TELEDYNE CONTINENTAL ® AIRCRAFT ENGINE
SERVICE BULLETIN

Category 3
SB11-3

SUBJECT: Alternator and Drive Coupling Installation

MODELS AFFECTED: IO/TSIO520, IO/TSIO550, IOF/TSIOF550, TSIOL-550, and GTSIO520 Engines with Gear Driven Alternators

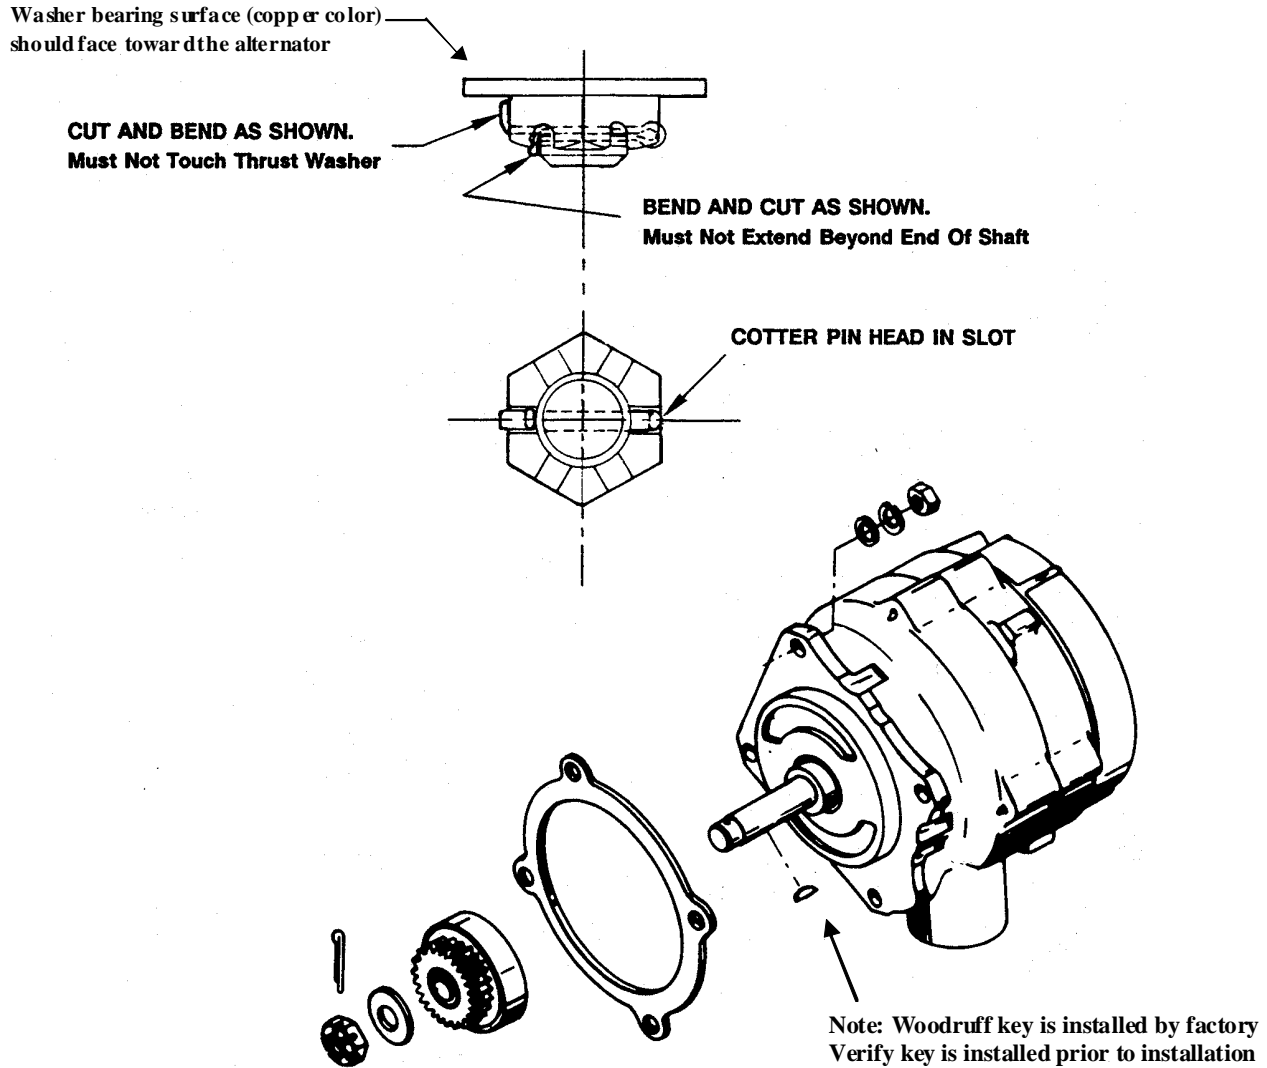
1. Remove shipping spacer and washer from the alternator shaft and discard

Installation of the drive coupling assembly on alternators with the shipping washer in place will cause interference with the face gear on the crankshaft and will result in damage to the engine and alternator.

2. Install coupling assembly and washer. The washer is a special thrust washer and must be installed with the bearing surface (copper color) toward the alternator. Install nut and tighten to 300 in. lbs. torque. If slots in the nut do not align with the cotter pin hold in alternator shaft, the nut may be tightened further but not to exceed 450 in. lbs.
3. Do not back off nut to align holes. Install cotter pin as shown to insure clearance when alternator is installed in engine.
